Addendum 2
Solicitation 20-99512
Fiber Optic Connection along Lake Avenue

This addendum serves to notify all bidders of the following changes to the solicitation documents:

CITY OF DULUTH
LAYOUT
LIFT BRIDGE FIBER CONNECTION

SHEET
9
OF
10

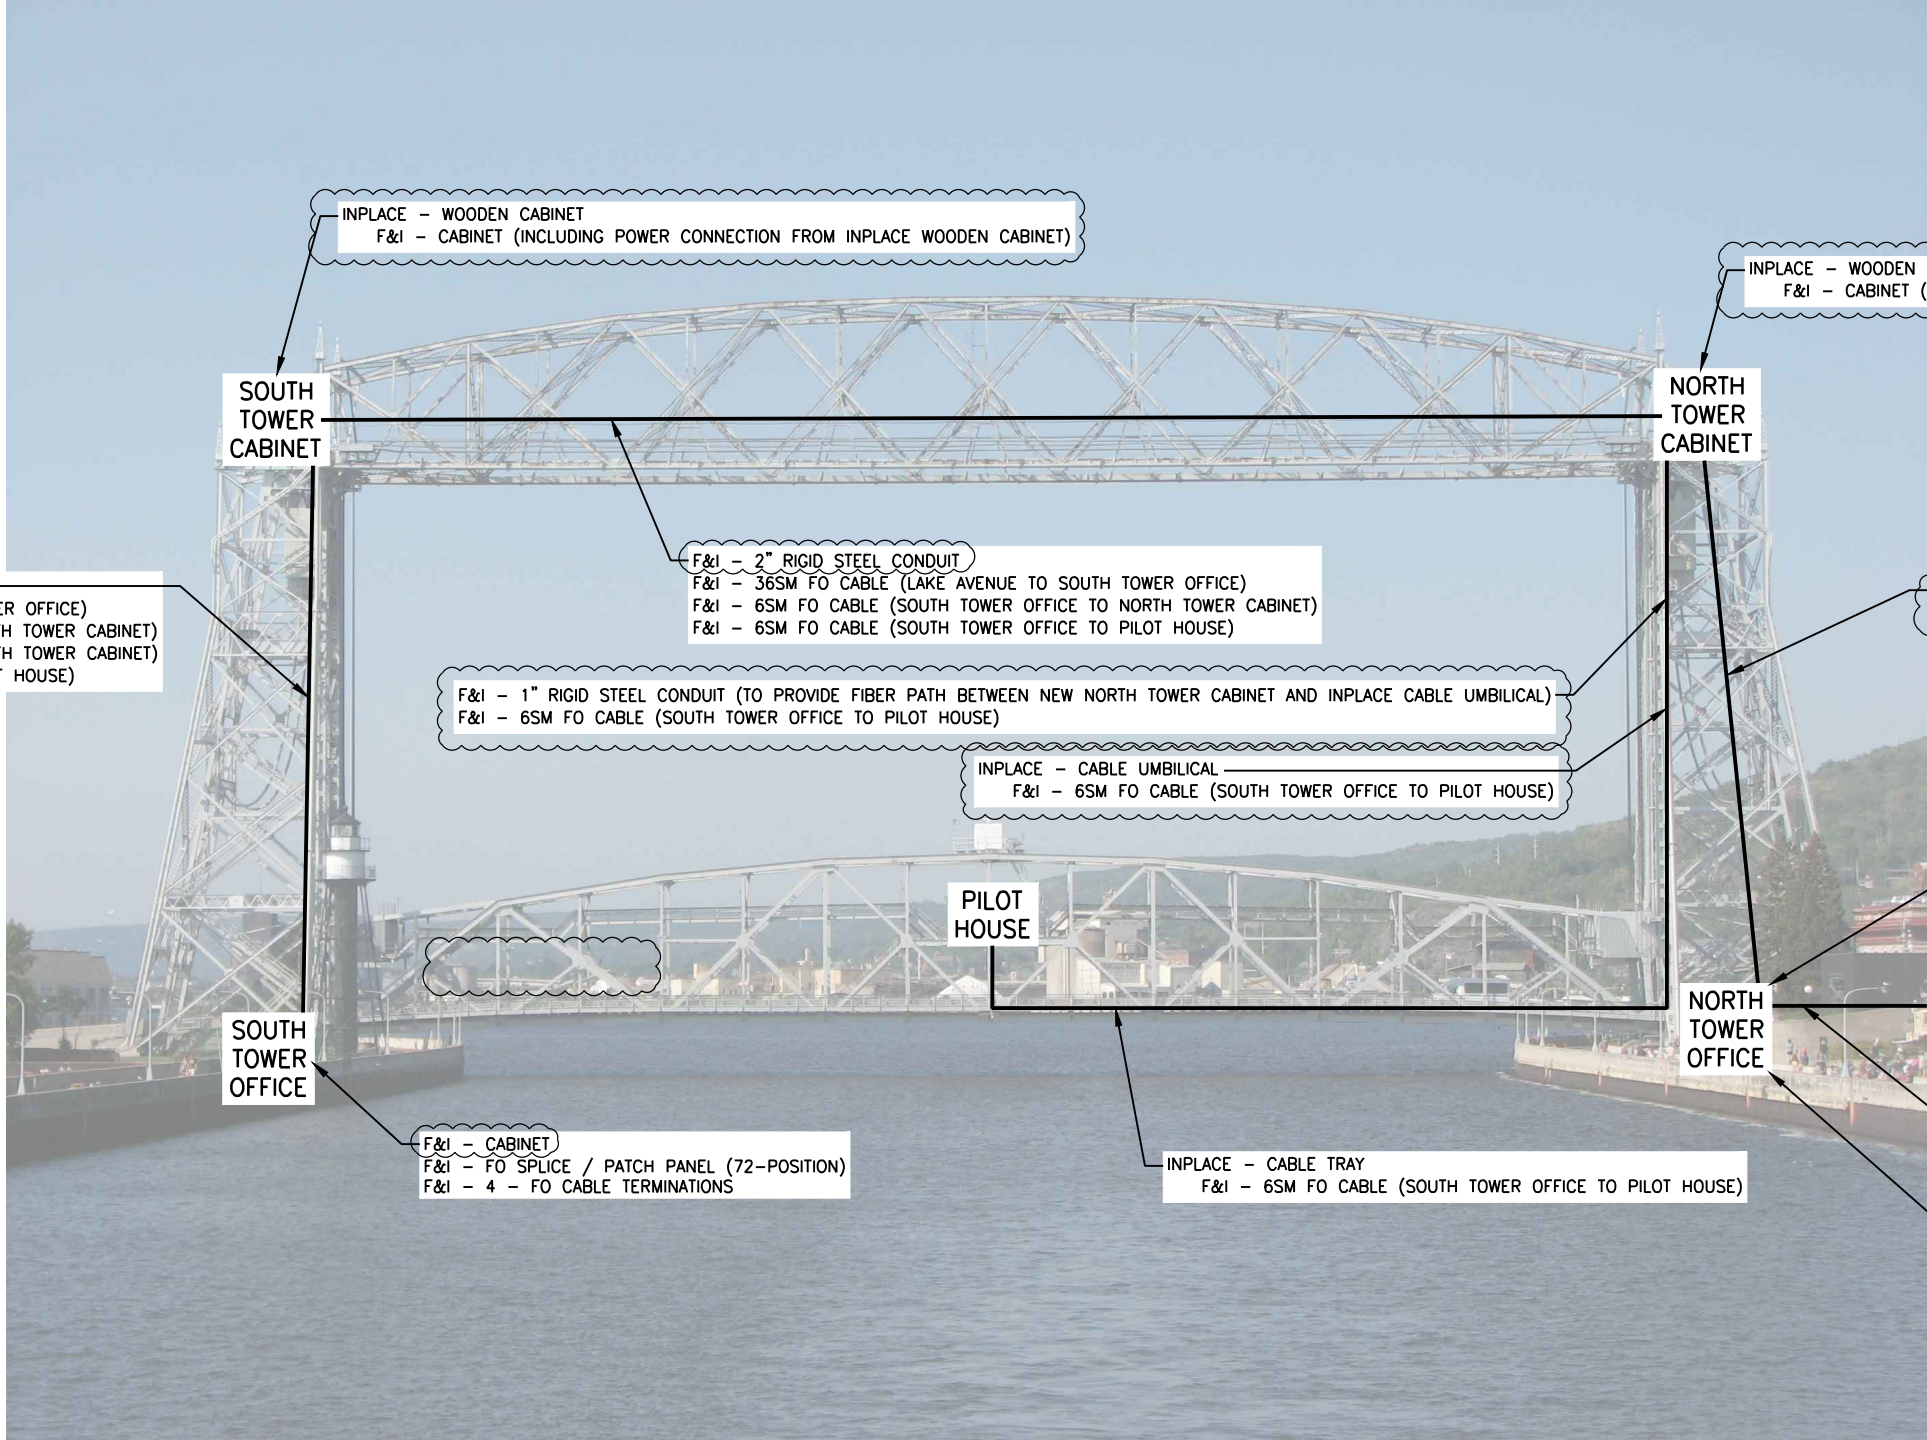
1. Changes have been made to sheets 2, 9 and 10 of the planset and are identified by revision bubbles. The revised sheets are attached and are hereby included in the bid documents. Changes include:

- a. Updated plans to clarify location and lengths of slack fiber service loops
 - b. Updated plans with conduit size (varies) and type (changed to RSC)

1	10/21/2020	LSJ	JF	JF	UPDATED NOTES TO CLARIFY LOCATIONS OF COILED FIBER OPTIC CABLES
NO	DATE	BY	CKD	APPR
